EXCEPTION TO COUNTY ROAD AND STREET STANDARDS

ROMBAUER VINEYARDS # P19-00130-MOD
Planning Commission Hearing Date 5 August 2020

To:	Wyntress Balcher, Planning	From:	Jeannette Doss, Engineering JD
Date:	July 9, 2020	Re:	Rombauer Vineyards Evaluation of Napa County Road and Street Standards Exception Request 3522 Silverado Trail, St. Helena, CA P19-00103 APN 021-410-025-000

Re: P19-00103, Rombauer Vineyards Winery Use Permit Major Modification and Road Exception Request, 3522 Silverado Trail, Napa County, CA, APN 021-410-025

DRIVEWAY WIDENING PLAN

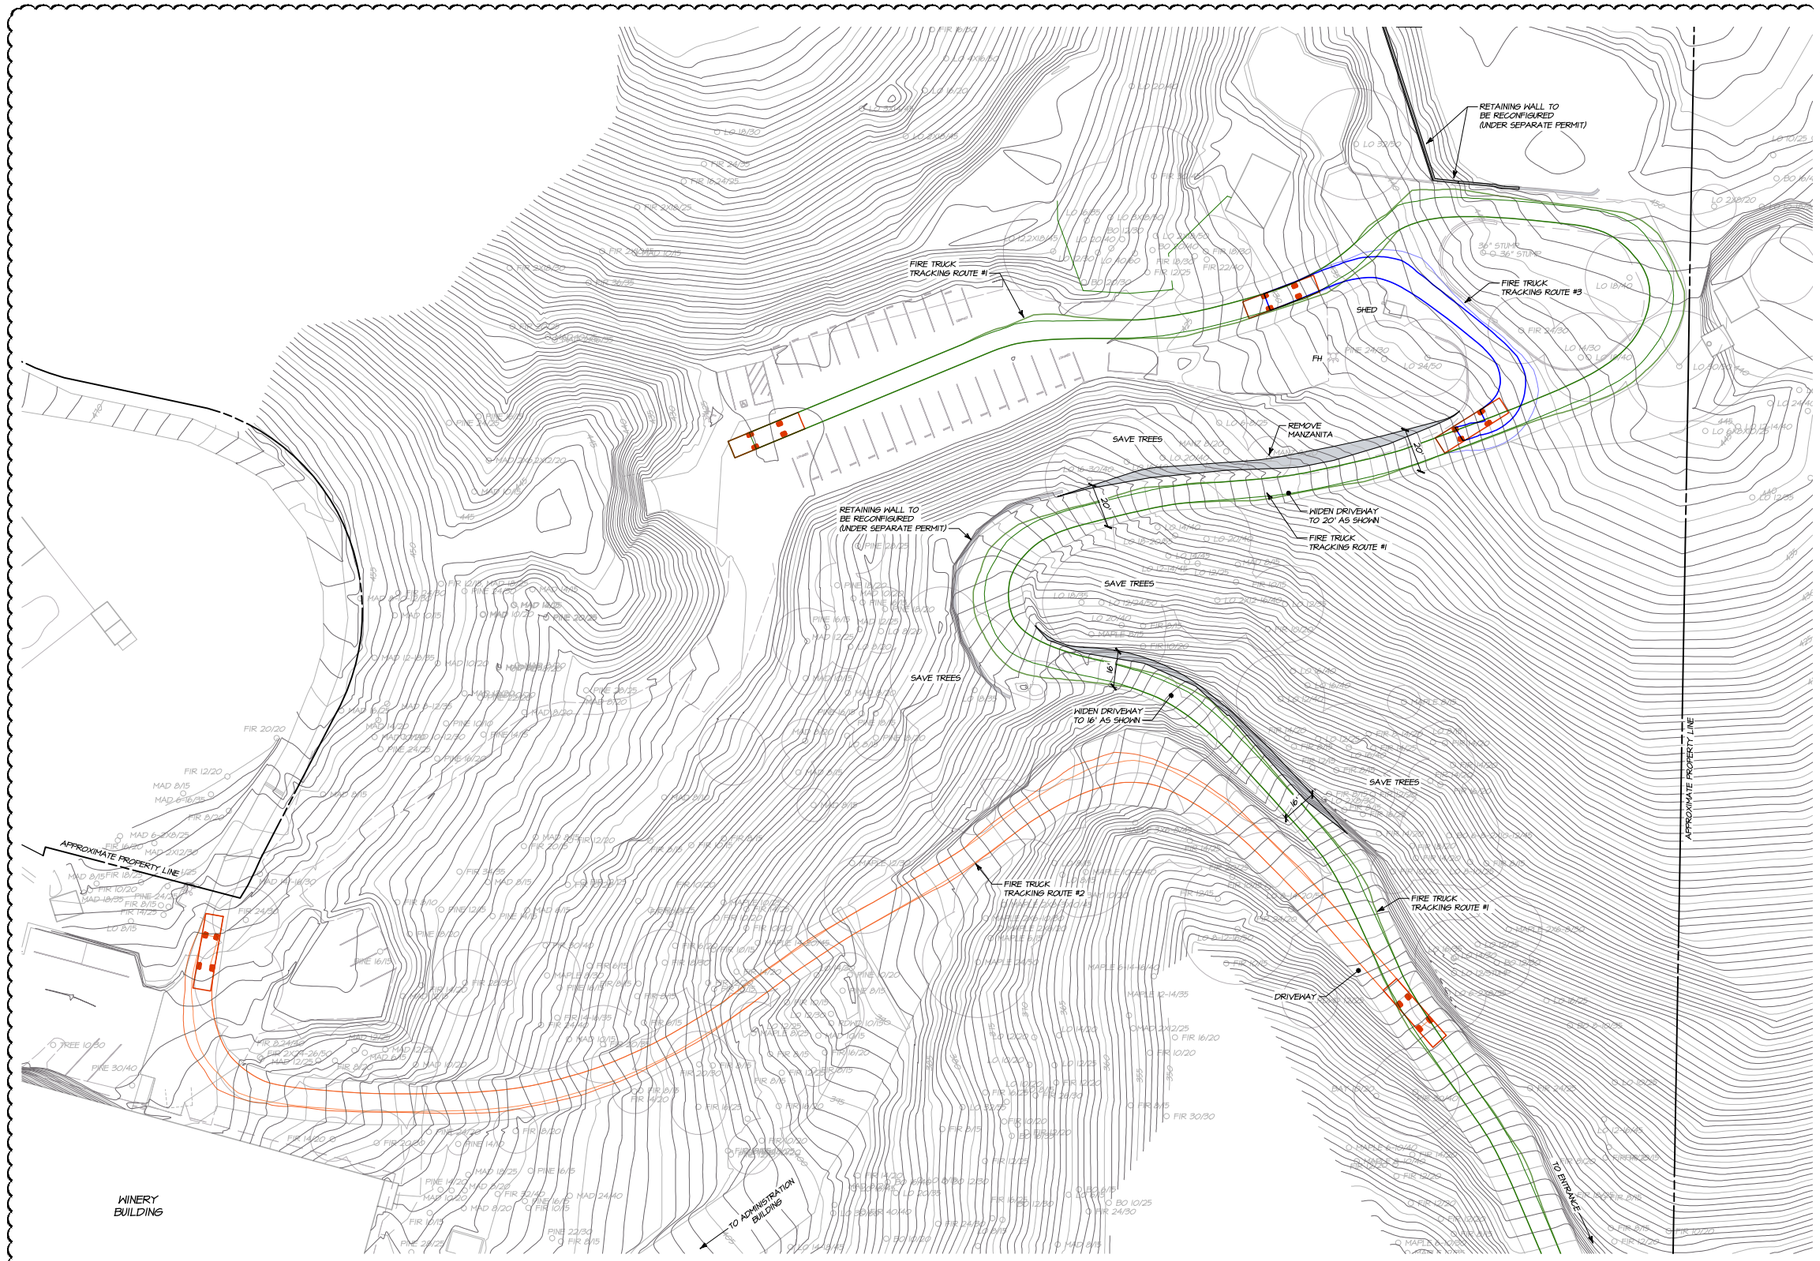
This section of the existing access road narrows from 40 feet wide (at the intersection) to 19 feet wide and widens back to 22 feet wide in approximately 20 feet and 30 feet respectively. This section of access road is confined by steep slopes both on the uphill side and on the downhill side, it additionally abuts a number of mature oak and fir trees. Refer to Sheet UP5 for size and type of trees.

This section of the access road is a hairpin turn with an inside radius of approximately 20 feet; however, the 30 feet of road width through the turn provides sufficient room for a fire truck to navigate the turn. Refer to Sheet UP5 for fire truck tracking, and size and type of trees adjacent to the access road.

ROAD AND STREET STANDARDS EXHIBIT

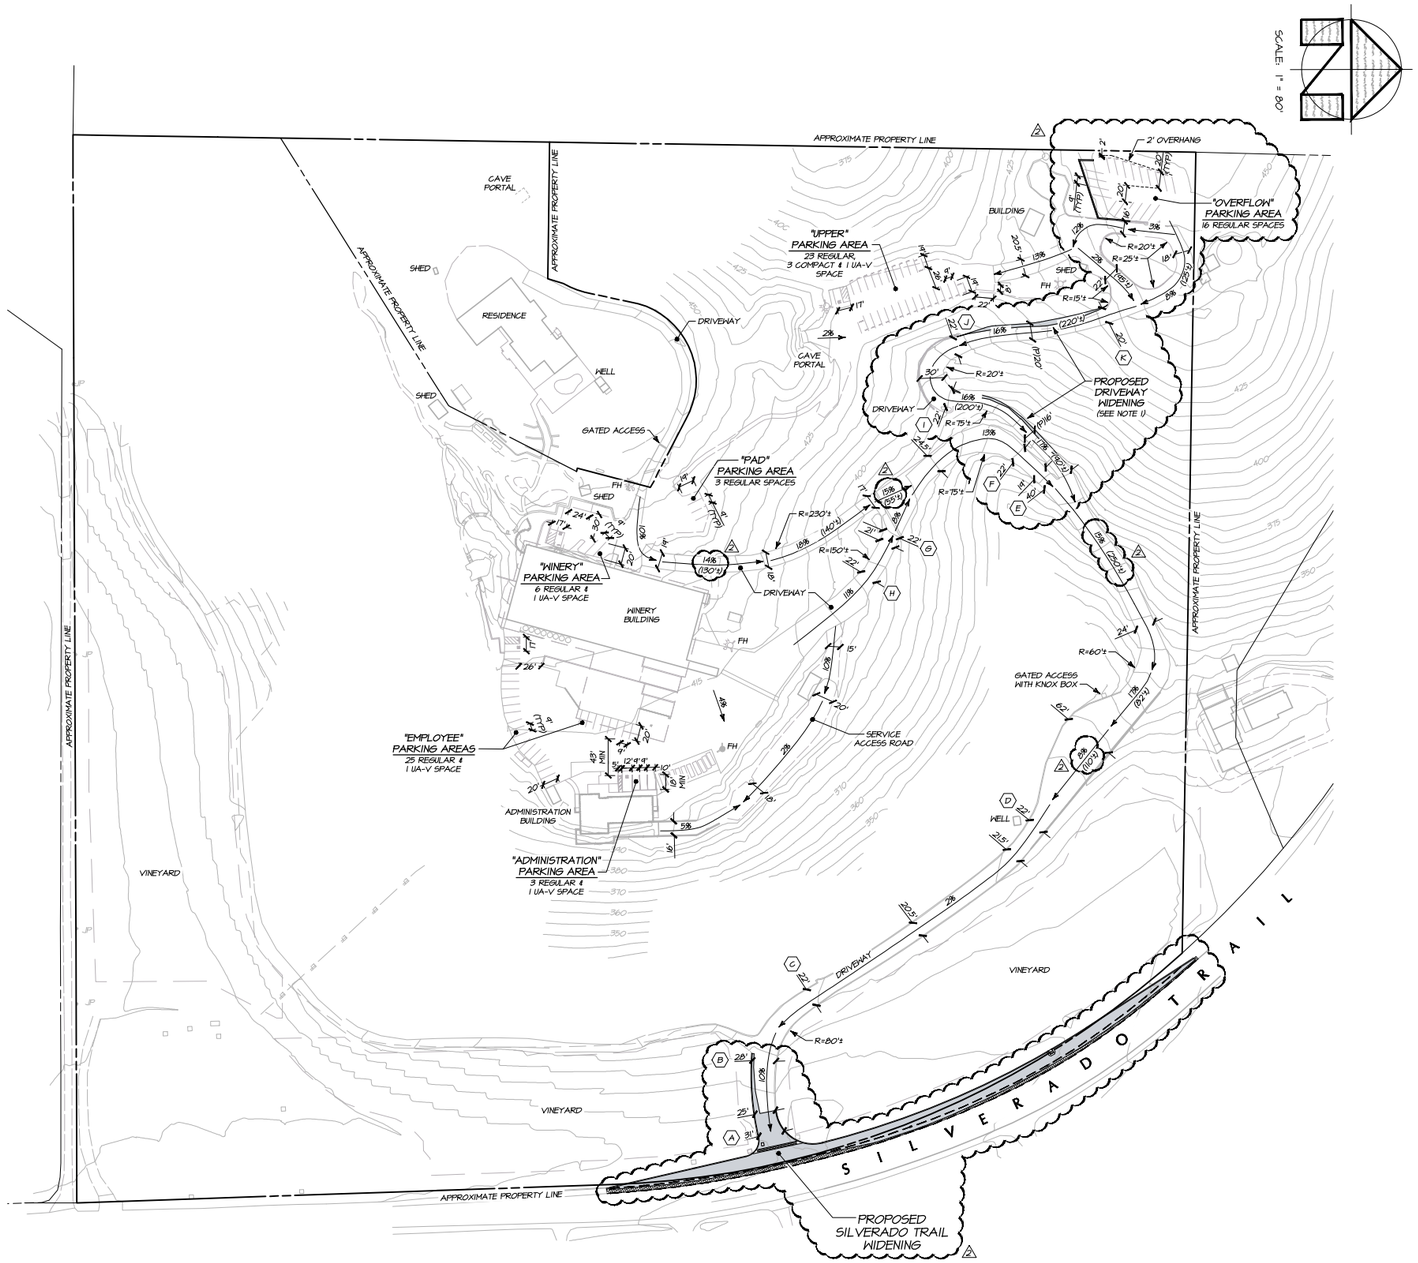
The existing access roads currently provide the same overall effect as the Road and Street Standards. All Napa County standards for centerline slopes less than 20% and structural section are met. The following is a narrative description of the portions of the existing access roads requiring exceptions. Refer to Sheet UP6 for the locations associated with the following narrative descriptions.
